WORKSHOP AGENDA

Planning Commission

October 14, 2025 @ 5:30 PM

Item #: 3. Site Plan - Dous Retail Center - Building totaling 4,200 Square Feet on 1.28 Acres. Requested by Chet Rhodes. Property located at 5130 Murfreesboro Road (Tax Map 15M, Group A, Parcel 1). C-2 (Highway Service) Zoning District. Property owned by TN Group Properties, LLC.

SHEET NO. C1.01

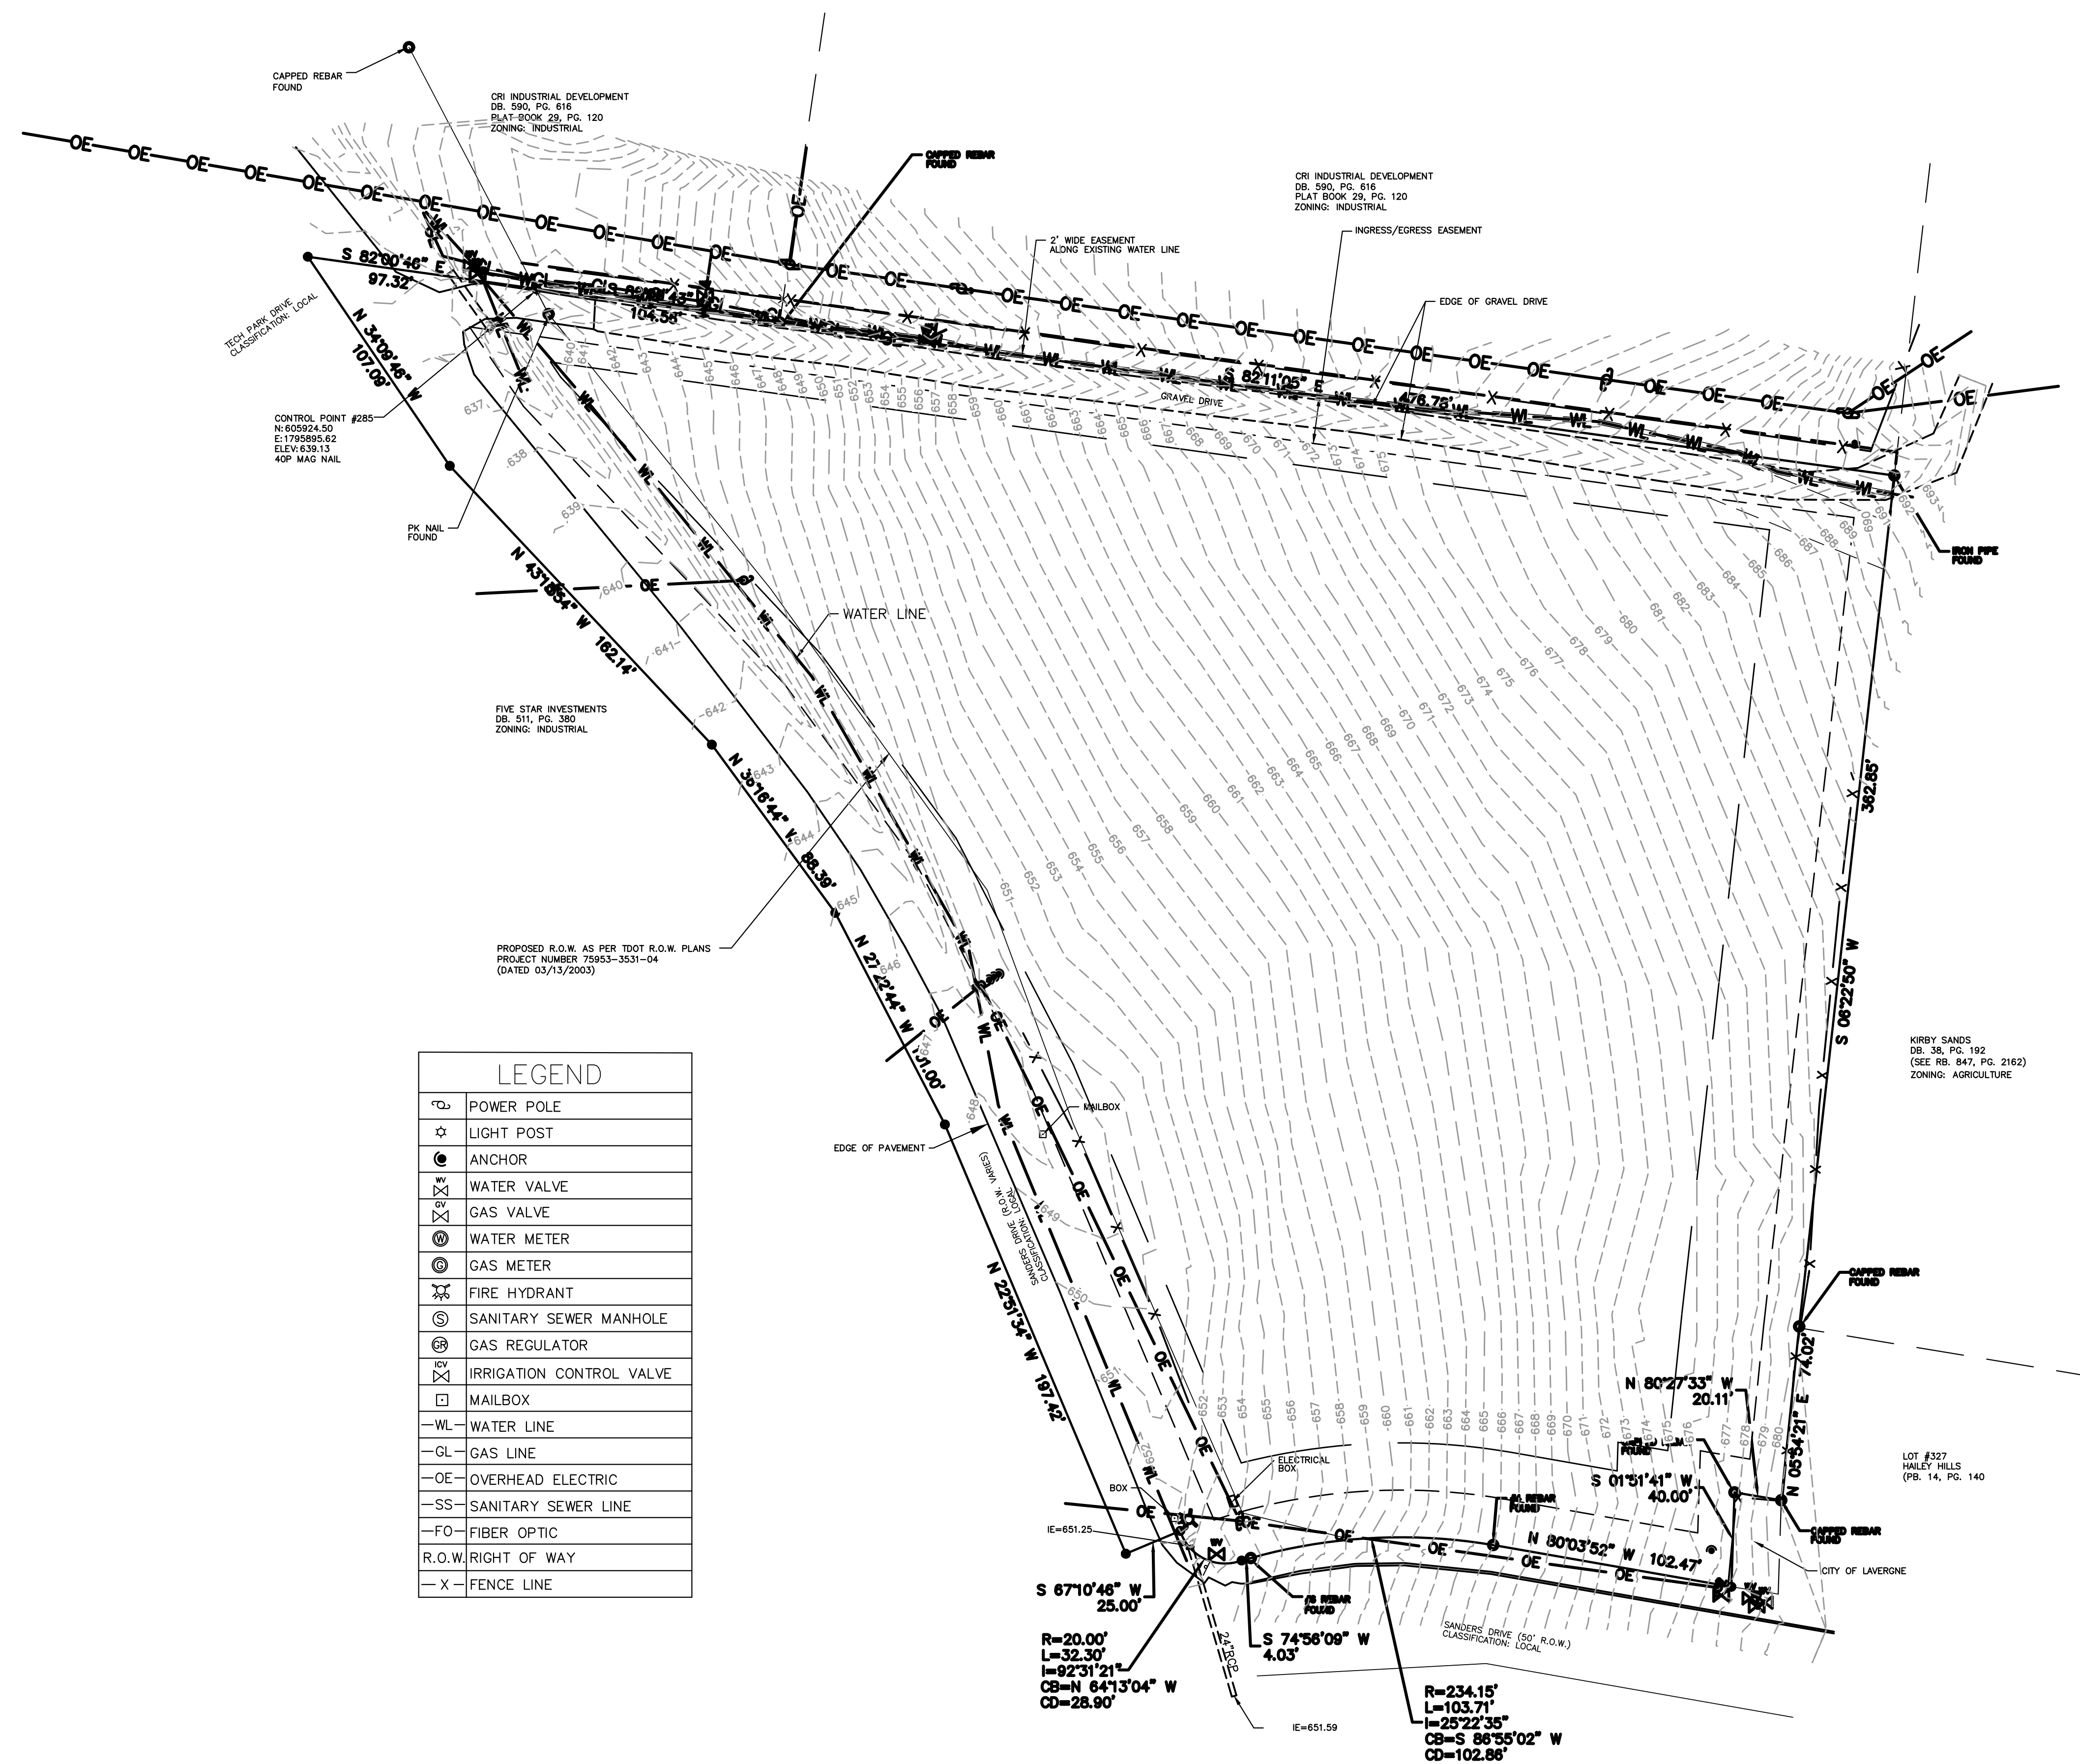
1. (Sheet C1.01) Staff recommends that applicant dedicate additional Public Utility and Drainage Easement (PUDE) as described in the Utilities section below.

2. (Sheet C1.01) Add DB 291 PG 475 for 2' waterline easement along north boundary.
3. (Sheet C1.01) Staff recommends that applicant dedicate sufficient land for Mason Road right-of-way

4. (Sheet C1.01) Correct scale in title block
5. Provide filled out draft of the Longterm Maintenance Agreement (LTMA) and Longterm Maintenance Plan (LTMP)

10. (Sheet C1.01) Easement width on existing water line is shown as 2'. Show correct easement width.
11. (Sheet C1.01) Show DB and PG for easements.
12. (Sheet C1.01) Correct note where Mason Road is incorrectly labeled as Sanders Road.

43. (Sheet C1.01) Show tree masses.
44. (Sheet C1.01) Show areas where slopes exceed 12% and show USDA-NRCS soil types for those areas.
45. Provide a Site Profile that runs from their northwest corner of the site running southwest through the building and down to the centerline of Mason Road.

SHEET NO. C2.01

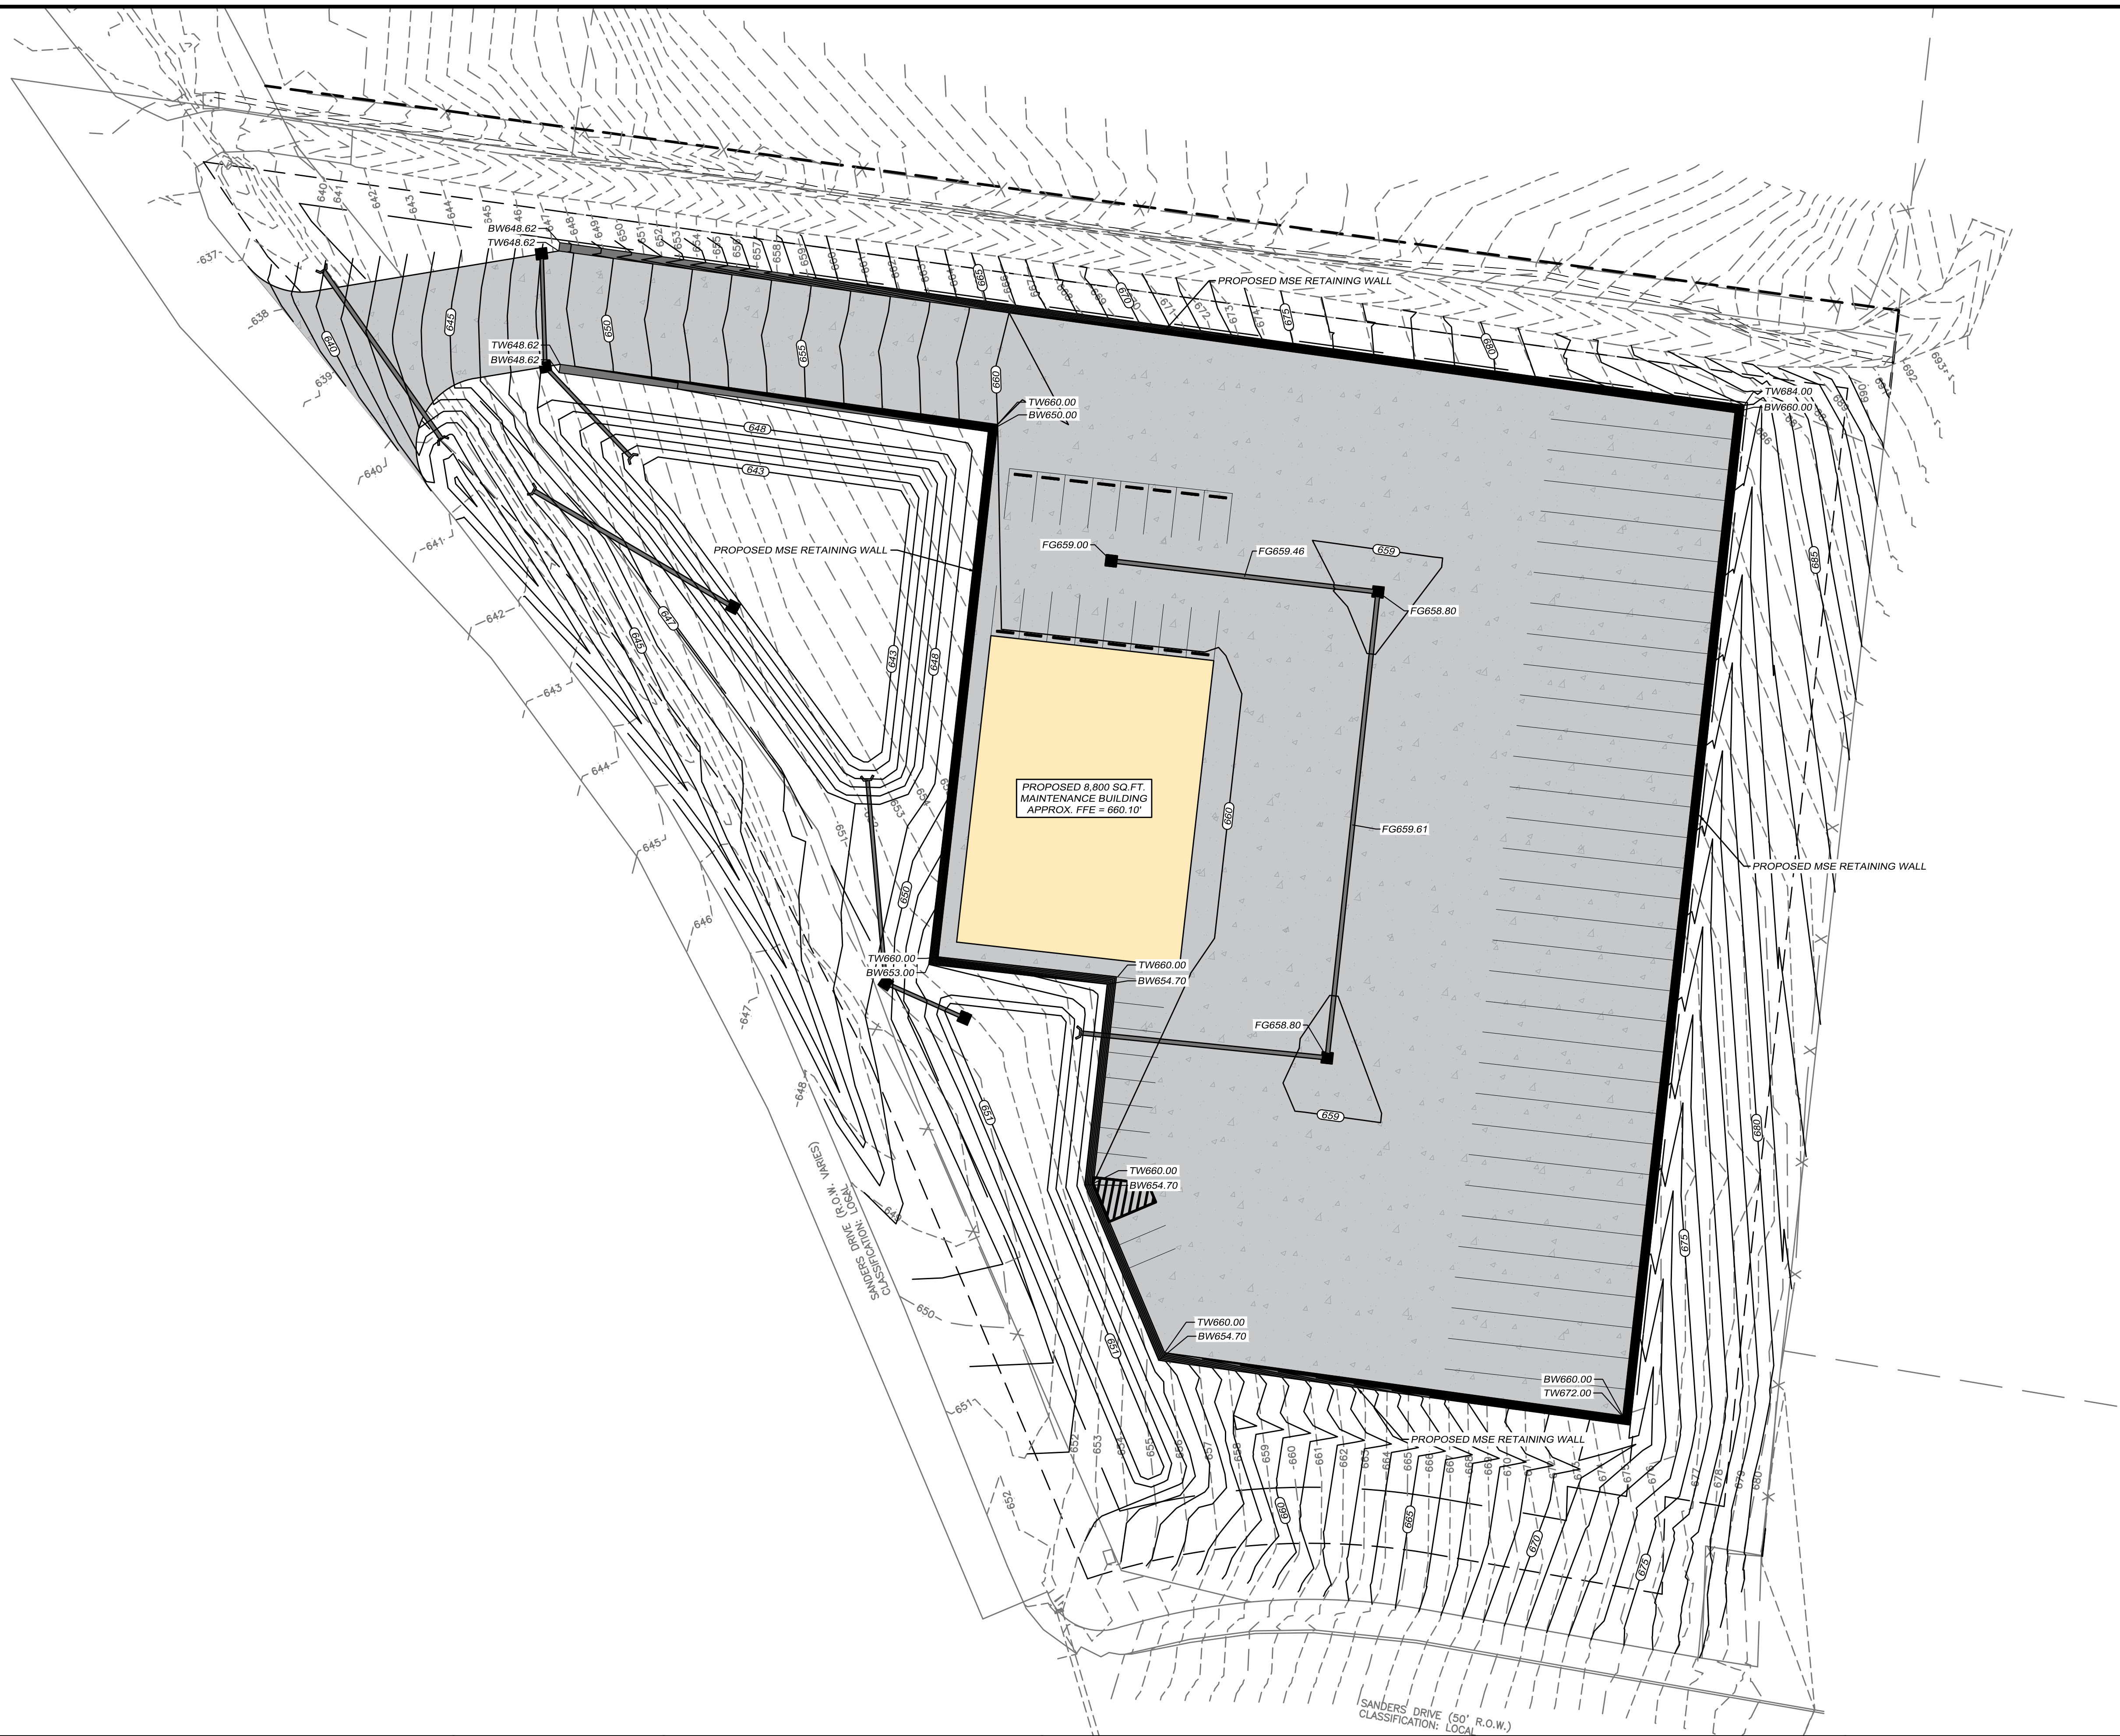
6. (Sheet C1.01) Move bearings and distances on north boundary so that they can be read.
7. (Sheet C2.01) Show distances from edge of paving to property boundaries along all boundaries.

8. (Sheet C2.01) Show distances from two perpendicular boundaries to the building so that the building can be located in the field.
9. (Sheet C2.01) Show lane striping for entry drive.

13. (Sheet C2.01) Provide concrete pavement section for drive and parking areas
14. (Sheet C1.01) Add DB 593, PG 125 to the access easement
15. While a full traffic study will not be required, please provide traffic generation estimates for the proposed use.

16. (Sheet C2.01) Provide ADA accessible spaces as required
17. (Sheet C2.01) Question: Is a monument sign proposed at the road? If yes, please show location and size.

32. (Sheet C2.01) Show far side edge of pavement for Mason Road and show edge of [pavement for Tech Park Drive
33. (Sheet C4.01) Show size, material, and invert elevations of existing pipe under the access drive along the North boundary

46. Provide a Site Profile from the centerline of Mason Road and following the centerline of the driveway to the nearest point of the building.
47. (Sheet C2.01) Show five-foot wide sidewalk along all public road frontages

48. (Sheet C2.01) Show dumpster pad or provide a narrative explaining how waste will be handled without a dumpster.
49. The City specifications have required General Notes. These must be included. They can be found at: <https://www.lavergnetn.gov/DocumentCenter/View/4671/Permitting-and-Construction-General-Information-and-Requirements>
